Subject: Visit to Maple Meadow Mine, Fairdale, WV

Investigation of Ground Conditions at the Maple Meadow Mining Company, Maple Meadow Mine  
MSHA ID No. 46-03374

FIGURE 1  
MAPLE MEADOW MINE  
I.D. No. 46-03374

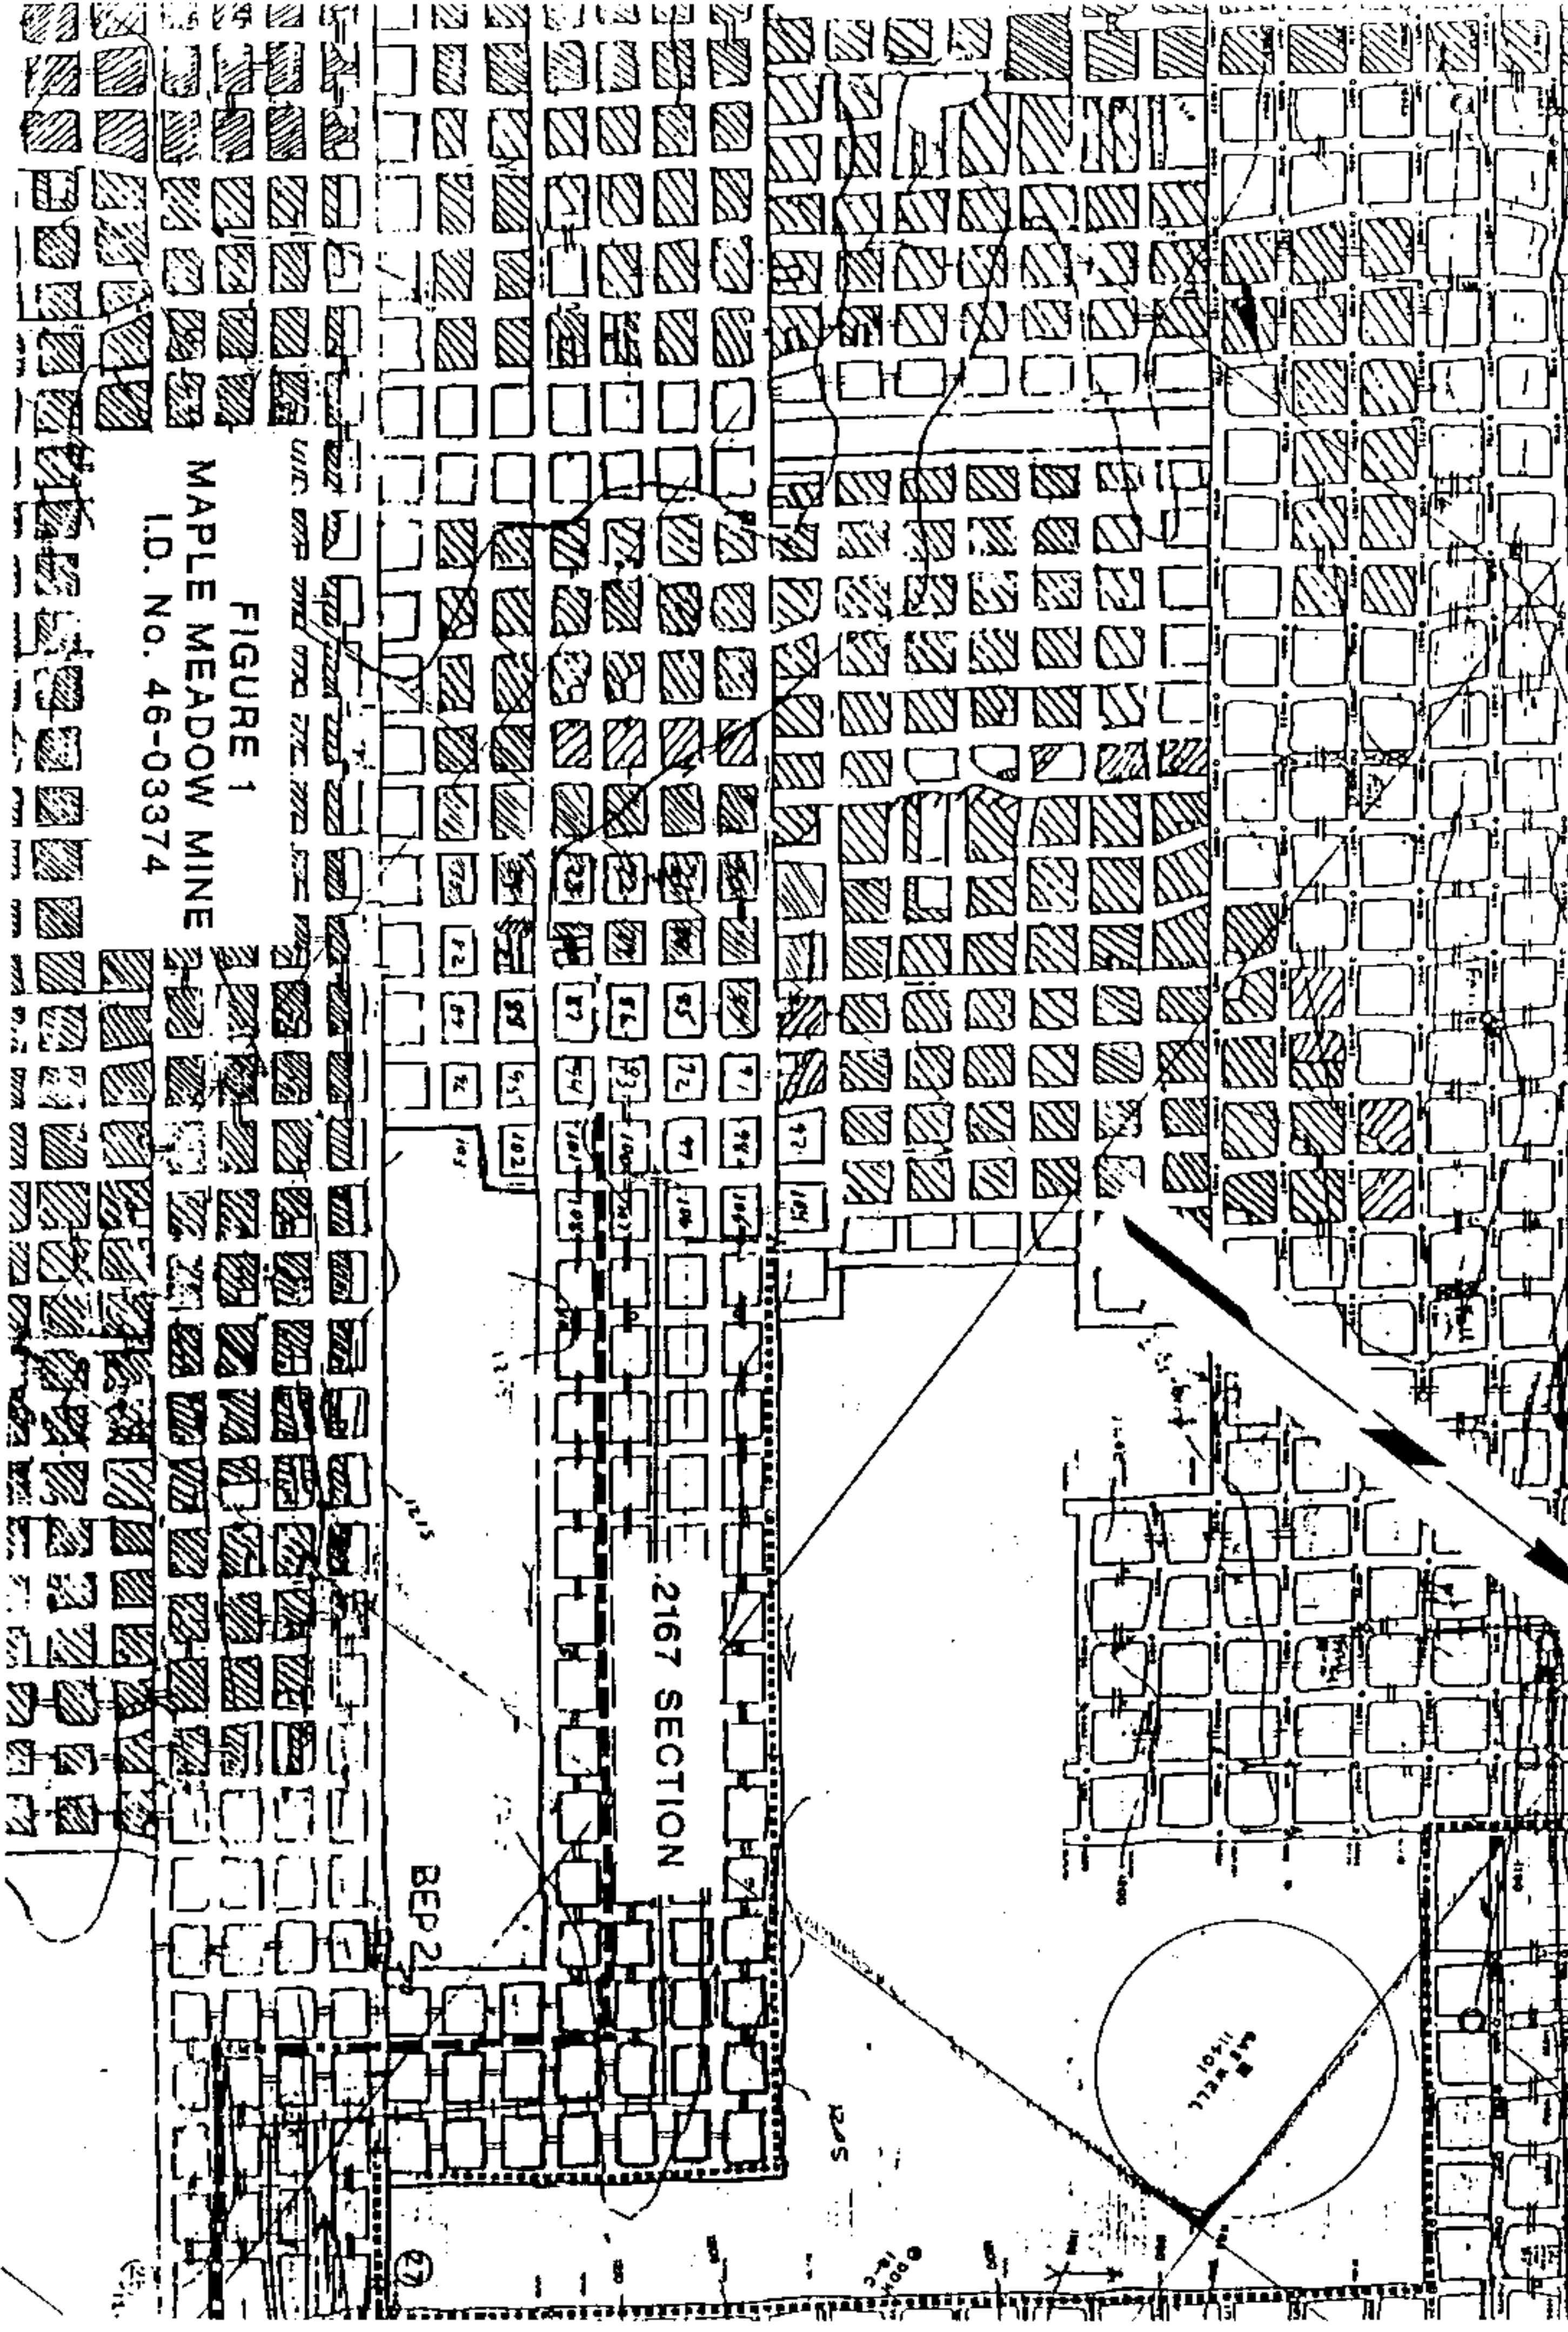
Conditions were examined throughout the face area of the 2167 retreat section (Figure 1). Pillars numbered 84, 78, 79 are shown as completely mined; pillar 80 was split in the crosscut direction with the inby half mined and the outby half still intact. Pillar 81 was split in the entry direction with twinning proceeding left one cut. On development, roof support was provided with 5-ft.-long fully grouted bolts installed on 4-ft. by 4-ft. centers. During retreat mining, roof support is

Pillar sloughing was extreme for three blocks outby the face area with numerous posts set as supplemental support. Generally roof conditions appeared stable except for the crosscut between pillars numbered 91, 92, 93 and pillars numbered 98, 99, 100 where numerous cribs had been set and appeared to be taking weight. Bottom heave was evident in most of the crosscuts within three blocks of the face. The crosscut outby pillars numbered 80, 81, 82 had to be graded for clearance before retreat mining in this area. Observations inby the number 80 and 81 pillars revealed no caving of the roof and that numerous stumps and posts were still intact. Observations inby the number 97 and 104 pillars revealed that caving of the roof appeared to have fallen only approximately 10 ft. high. The rib of the number 89 pillar facing the 88 pillar and the right outby corner of the 82 pillar showed evidence of bursting. The coal in these areas of the pillars was dislodged 3-ft. to 5-ft. and appeared crumbled and highly fractured. Conditions improved significantly three blocks outby the face as was evident by the lack of sloughing of the ribs and the lack of weight on the occasional post or crib.

- o The retreat mining of the 2167 section surrounded by gob on three sides greatly increases pressures in the immediate face area.
- o The deep cover (approaching 1200 ft. after later examinations of topographic overlays of the mine) just outby the immediate face area increases the vertical stress and adds increased pressure in the face area.
- o Increased pressure is also being applied to the face region due to the practice of leaving portions of pillars in the adjacent gobbed areas.

- o Mining of the barrier to the left of the number 1 entry of the 2167 section should be minimized. Mining only for the purpose of connecting ventilation is advised.
- o Mining to the right of the number 5 entry with the proposed system (four entries developed and then retreated back to the number 5 entry), coupled with the first recommendation of not mining the barrier to the left would still create a situation with gob on two sides of the active pillar line in the 2167 section. It is recommended that a mining plan be created and implemented whereby only one gob exists during retreat mining in the 2167 section.
